Request List for 111 Main St Hendersonville TN 37075

Last Modified: 2021-02-22 16:00:49

1. Awning Rail Trim (Curbside)

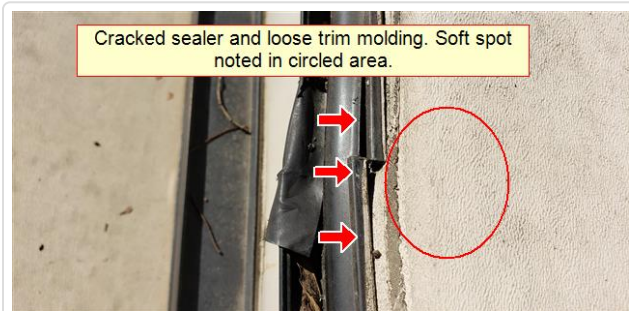
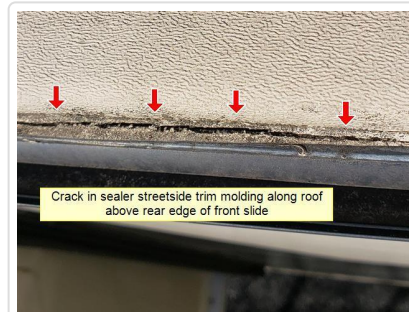
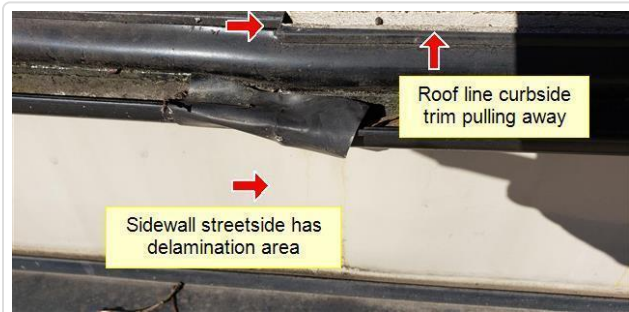
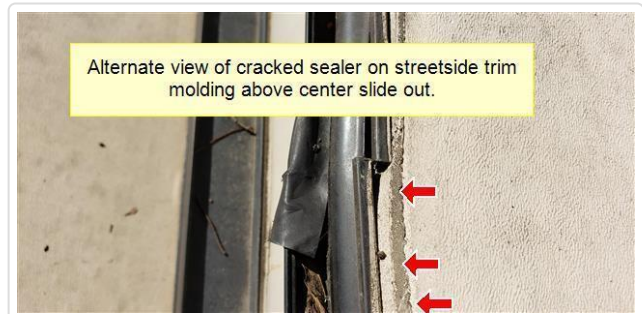
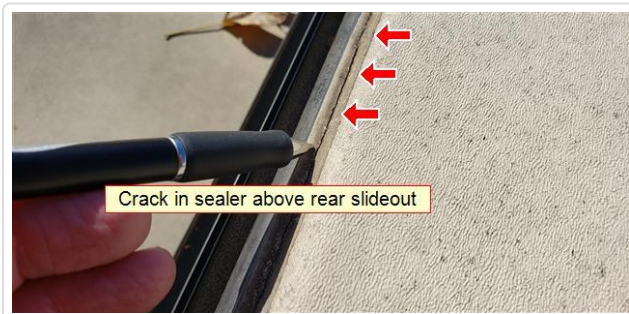
- Repair Requested
 - Customer Comment
 - Inspector's Comment
- 2.2 Most notable areas

1) Area approximately 13" from front cap

2) Two larger areas noted. One above front of awning and one above rear of awning.

It is recommended to have these inspected by a qualified RV technician.

2. Trim Rail (Streetside)

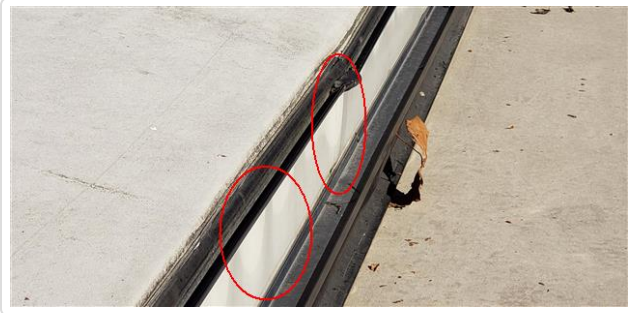
- **Repair Requested**
Customer Comment
- **Inspector's Comment**
2.4 Most notable areas

1) Area above rear slide out.

2) Above center slide out. In this area a soft spot approximately 1/2" in diameter was found in decking under rubber roof just above center streetside slideout along this edge.

It is recommended to have these inspected by a qualified RV technician.

3. Sidewall Condition

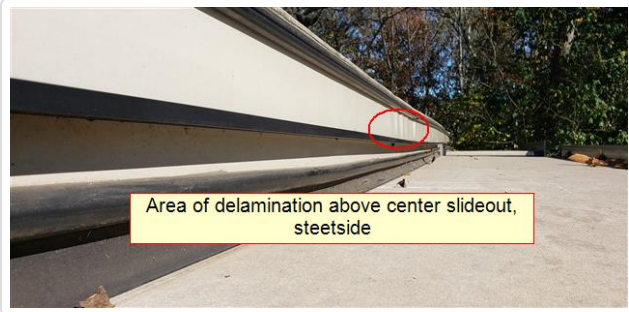
streetside wall above center slide out.

- **Repair Requested**
Customer Comment
- **Inspector's Comment**
3.0 C Inspector noted an area of delamination above the center slide out approximately . It is recommended to have this inspected by a qualified RV technician.

6. DOT Tank(s)

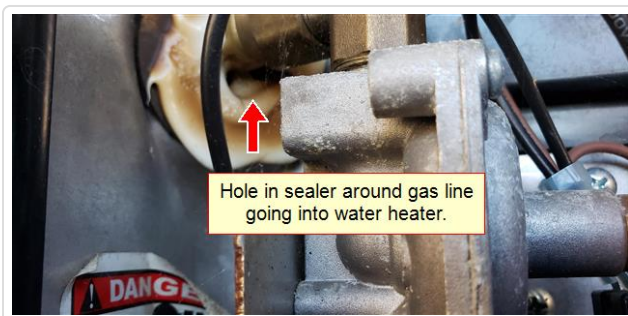
- Repair Requested
Customer Comment
- Inspector's Comment
13.0 Inspector noted the tank certification on the on the streetside tank is expired. It is recommended that this be checked by a qualified technician.
